Standards Update Transmittal

Reference Number: 2021-17
Standards: Standard Construction Specifications, Section(s) 19, 38, 49, & 50
Standard Drawing, SD-06.0, SD-06.1, SD-6.2, & ST-1A

1. Modification to Standard Construction Specifications:
 - a. Section 19 – Trench Excavation, Bedding and Backfill
 - b. Section 38 – Storm Drain Construction
 - c. Section 49 – Signals, Lighting, and Electrical Systems
 - d. Section 50 – Construction Materials
2. Modification to Standard Drawings:
 - a. SD - 6.0 Storm Drain Trench Detail
 - b. SD - 6.1 Storm Drain Pipe Bedding and Initial Backfill
 - c. SD - 6.2 Cutoff Collar
 - d. ST - 1A Trench Backfilling and Resurfacing

SD - 6.0

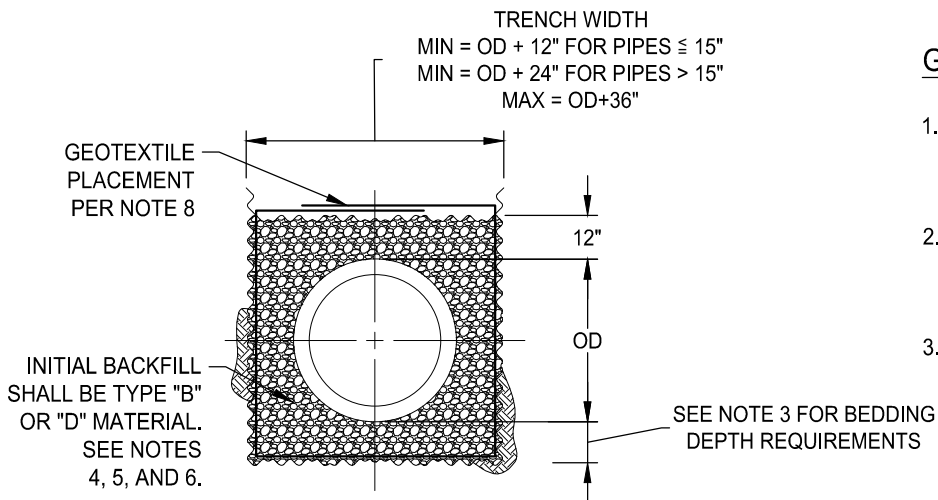
1. This modification will ensure that all the applicable standard drawings and standard construction specifications related to pipe bedding and trench backfill are uniform across all specifications.

TYPE "A" BACKFILL MATERIAL: 3/4" CLASS II AB AS PER SECTION 50 OF THE CITY STANDARD CONSTRUCTION SPECIFICATIONS.

TYPE "B" BACKFILL MATERIAL: 3/4" CLEAN CRUSHED ROCK AS PER SECTION 50 OF THE CITY STANDARD CONSTRUCTION SPECIFICATIONS.

TYPE "C" BACKFILL MATERIAL: JOB EXCAVATED NATIVE MATERIAL FREE OF ORGANIC OR UNSUITABLE MATERIALS THAT CAN CAUSE VOIDS OR DEPRESSIONS TO DEVELOP DURING OR AFTER PLACEMENT OF THE BACKFILL. ROCKS, STONES, AND SOLID EARTH CHUNKS EXCEEDING 3-INCHES IN GREATEST DIMENSION ARE NOT ALLOWED.

TYPE "D" BACKFILL MATERIAL: CONTROLLED DENSITY FILL AS PER SECTION 50 OF THE CITY STANDARD CONSTRUCTION SPECIFICATIONS.

TYPE "E" BACKFILL MATERIAL: CLASS "C" CONCRETE AS PER SECTION 50 OF THE CITY STANDARD CONSTRUCTION SPECIFICATIONS.

1. GEOTEXTILE SHALL BE INSTALLED AS PER STD DWG SD-6.1 AND AS PER SECTION 50 OF THE CITY STANDARD CONSTRUCTION SPECIFICATIONS.
2. INTERMEDIATE BACKFILL TO BE PLACED IN 8" MAXIMUM LOOSE LIFTS.
3. CUTOFF COLLARS TO BE INSTALLED EVERY MANHOLE RUN AS PER STD DWG SD-6.2 AND AS PER SECTION 19 OF THE CITY STANDARD CONSTRUCTION SPECIFICATIONS.
4. CONTROL DENSITY FILL (CDF) BACKFILL AROUND MANHOLES TO BE AS PER SECTION 39 OF THE CITY STANDARD CONSTRUCTION SPECIFICATIONS.
5. IF ROADWAY SUBGRADE IS WITHIN 12" OF TOP OF PIPE, BEDDING AND INITIAL BACKFILL SHALL CONFORM TO SHALLOW PIPE DETAILS AS PER STD DWG SD-6.1.
